Transport  
for NSW

# New Richmond Bridge and Traffic Improvements Stage 1 – The Driftway

Addendum review of environmental  
factors

July  
2024

Figure 1-1 Location of the proposed modifications

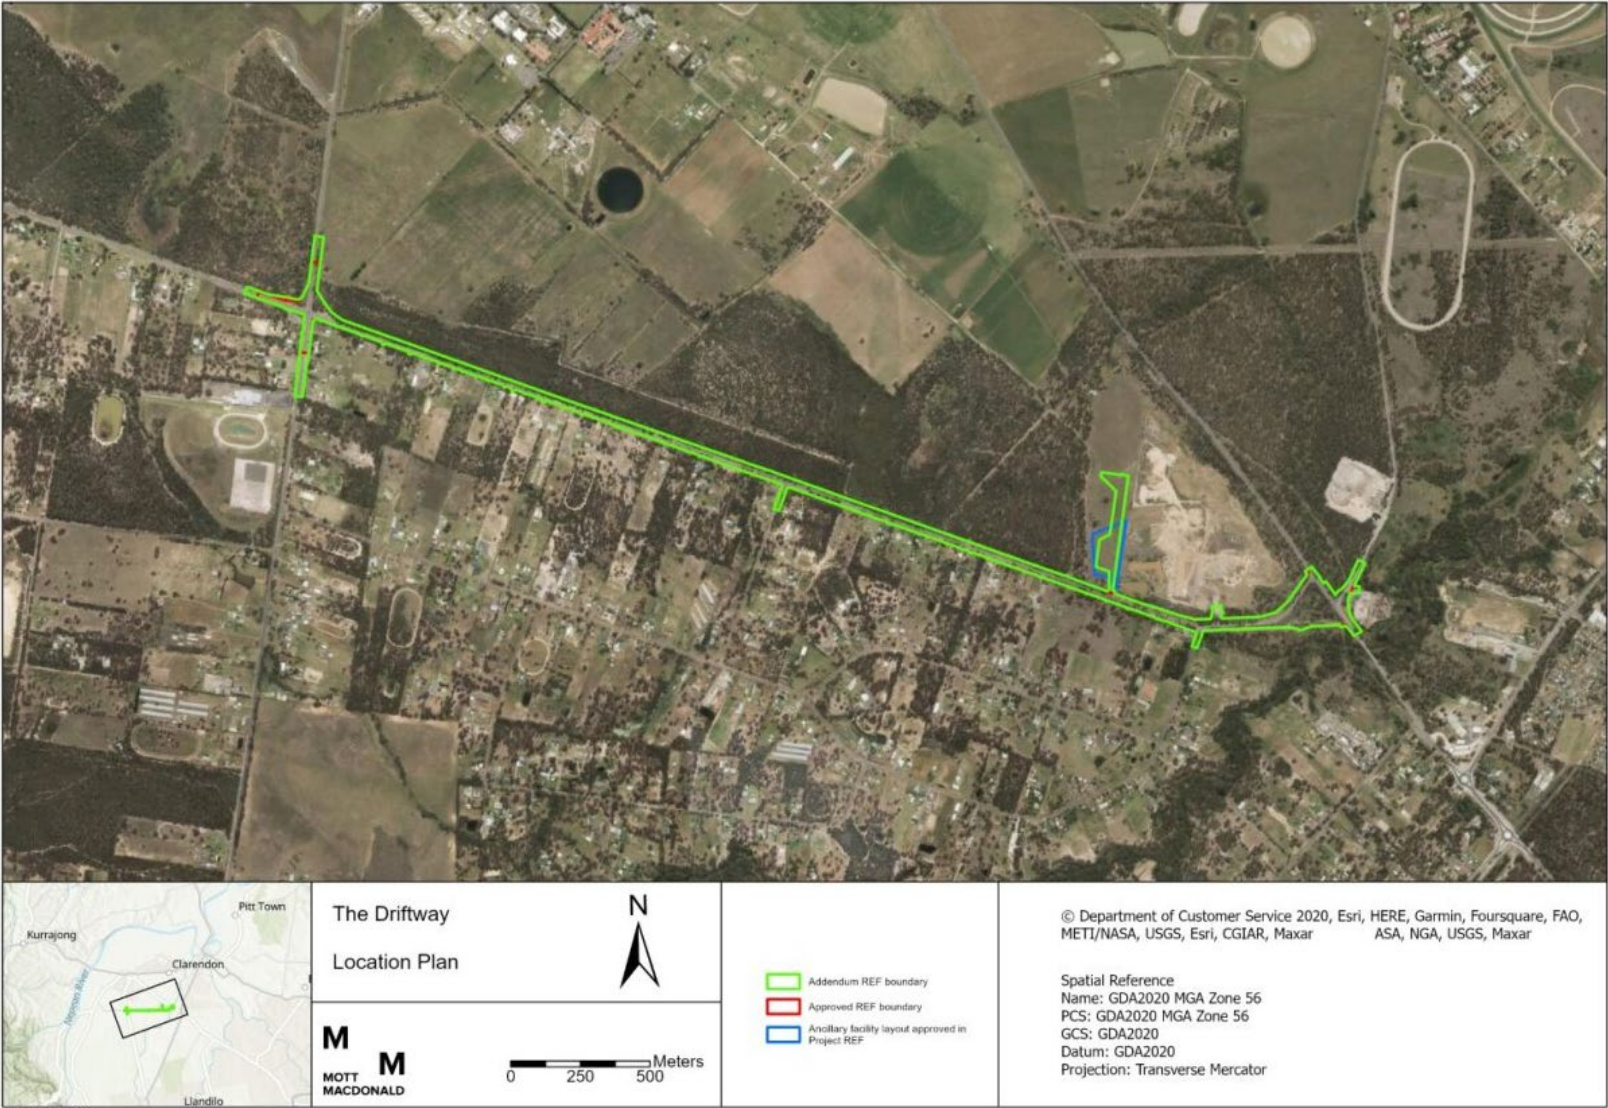
- Batters along the northern verge of The Driftway have been flattened, within the Project REF boundary
  - Modification of driveway tie-ins along Londonderry Road and The Driftway, in some locations modifications extend beyond the Project REF Boundary.

Further detail on the proposed modifications is discussed in Section 3.1. The location of the proposed modifications is presented in Figure 1-1.

Figure 3-1: Key features of the proposed modifications

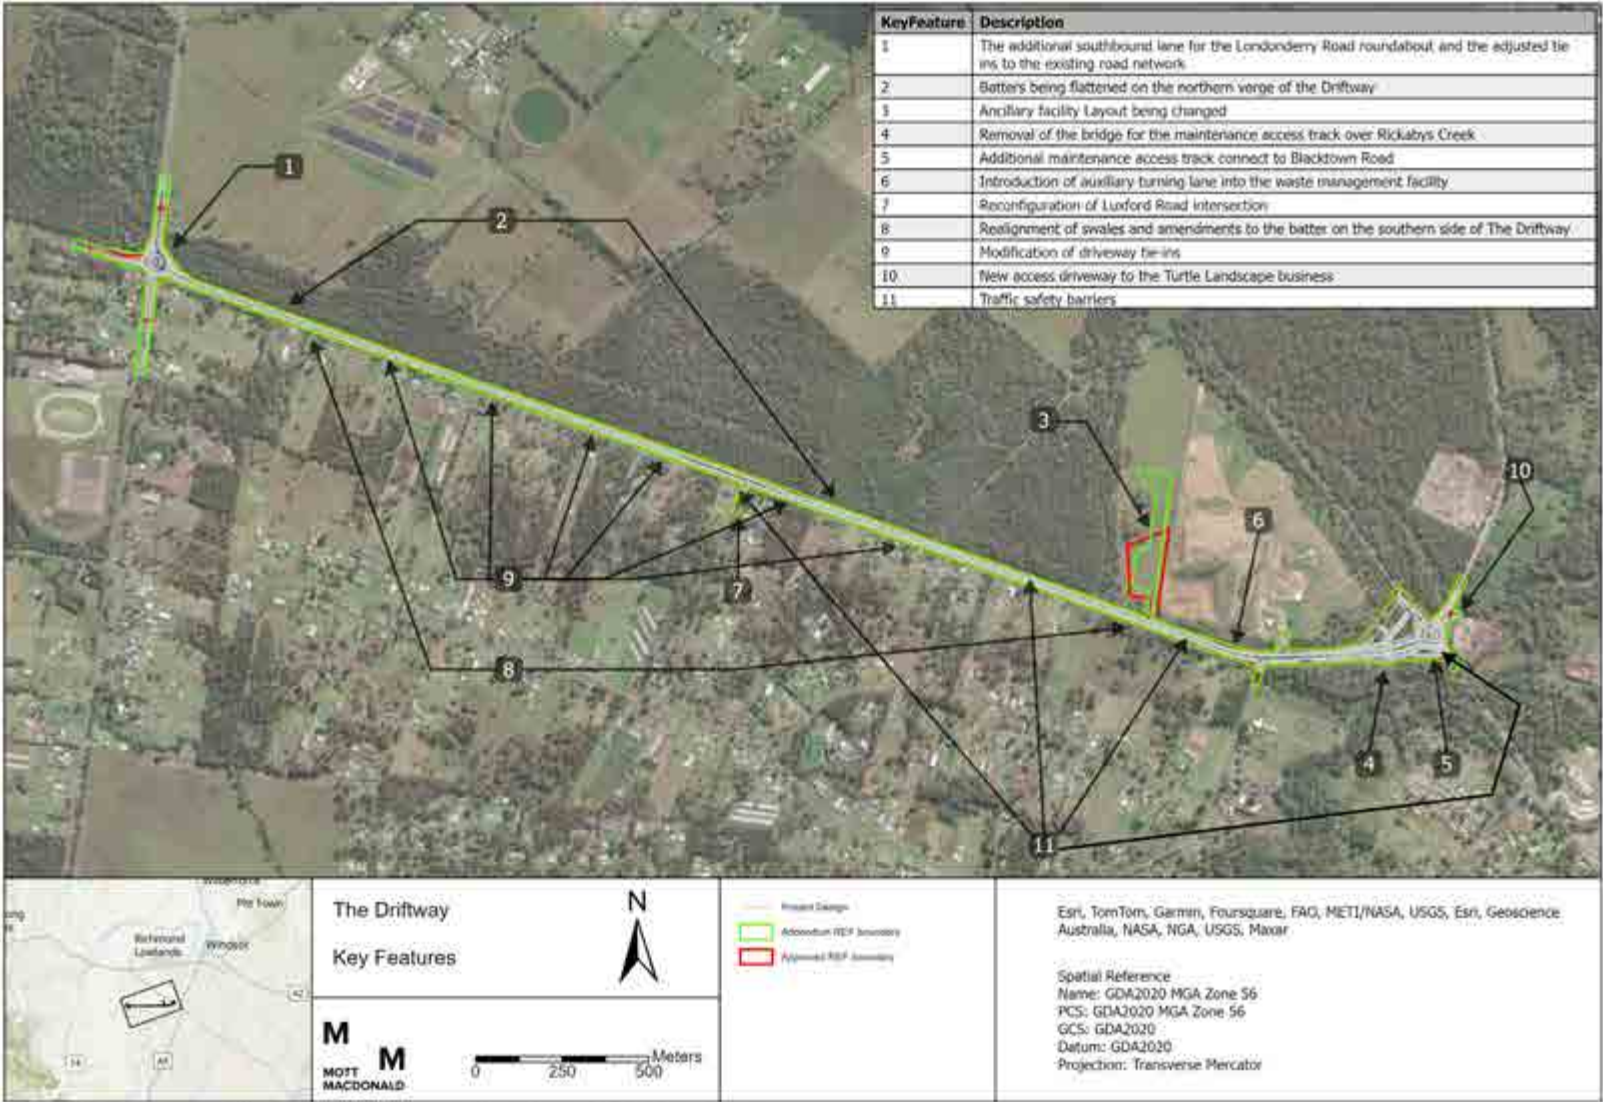
Transport for NSW proposes to modify New Richmond Bridge and traffic improvements Stage 1 – The Driftway through the addition of lanes and further modification of existing lane design. The location of the proposed modifications are shown in Figure 3-1 to Figure 3-3. In addition, the detailed design plans are included in Appendix H.

Key features of the proposed modifications would include:

- Modification of driveway tie-ins along Londonderry Road and The Driftway, in some locations modifications extend beyond the Project REF Boundary.

Figure 3-7 Ancillary facility location and PCT 849 communities

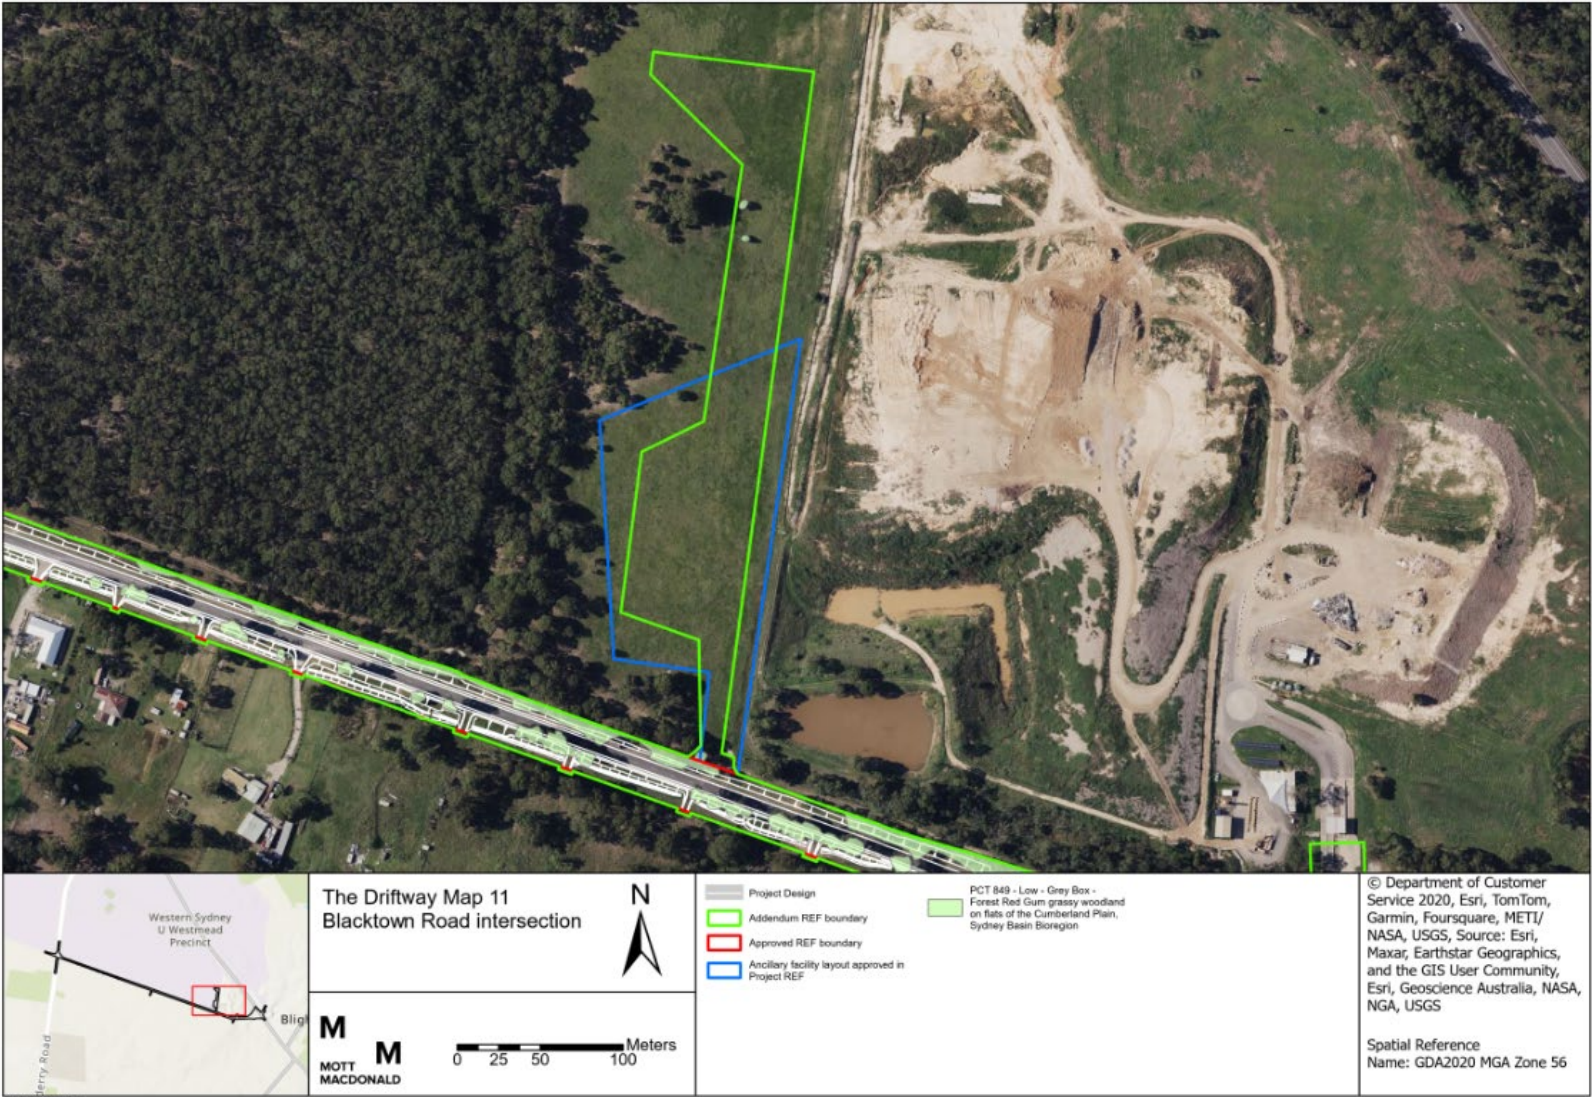
The layout of the ancillary facility has been modified to avoid areas mapped as having high flood potential. The new layout of the facility has proposed to increase the impact area by 0.1 ha from 1.9 ha to 2 ha compared to the Project REF. As the resulting shape of the proposed site is less uniform, the size has been increased to enable flexibility for construction laydown areas while maintaining avoidance of flood prone areas. This is presented in Figure 3-7.

The location of the ancillary facility identified in the Project REF is proposed to be modified to avoid flooding as the original location of areas mapped as having high flood potential. The proposed modifications would increase the size of the site from 1.9ha to 2ha and alter the ancillary facility layout to reduce the risk of flooding during the construction phase. The modified layout has also been designed with the goal to maintain flexibility for construction contractors to determine laydown areas required for construction given the less uniform shape of the proposed modification. In addition, negotiations were held between Western Sydney University and Transport on the lease of the Ancillary facility which informed the revised shape shown in Figure 3-7.

Figure 3-8 Additional Acquisition Areas to enable the proposed modification.

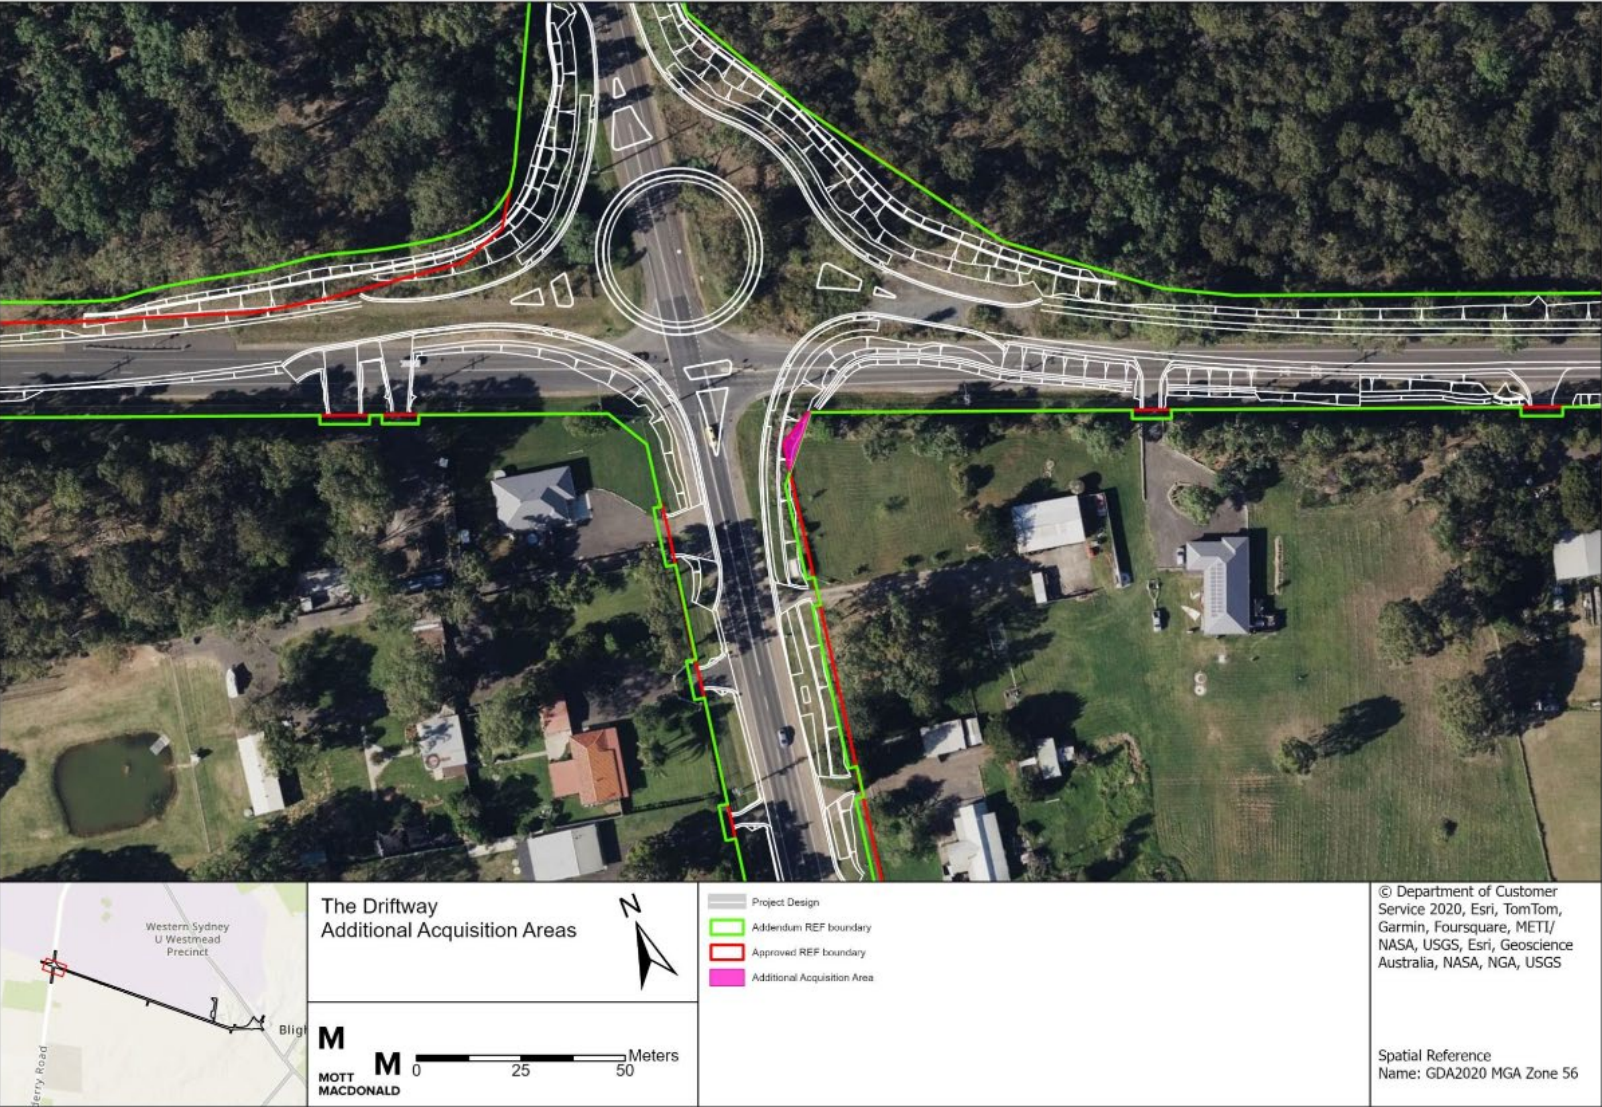
Table 3-3 provides a summary of the additional property acquisition required to accommodate the Proposed Modifications. This is the partial acquisition of 0.01 ha of lot 2 DP52477, located on the southeast corner of the Londonderry roundabout, see Figure 3-8. This partial acquisition is required to provide space for a new southbound lane on the roundabout. In addition, the amended area of the proposed ancillary facility requires the lease to be adjusted to consider the change in area and size of the site.

Consistent with the Project REF, specific designs in six locations have been prepared during detailed design to enable existing driveways to tie-in with the new road level. This would require temporary access to private property for maneuvering of construction plant during construction. The AREF boundary has been revised to accommodate these areas this can be seen around the driveway areas in Figure 3-8.
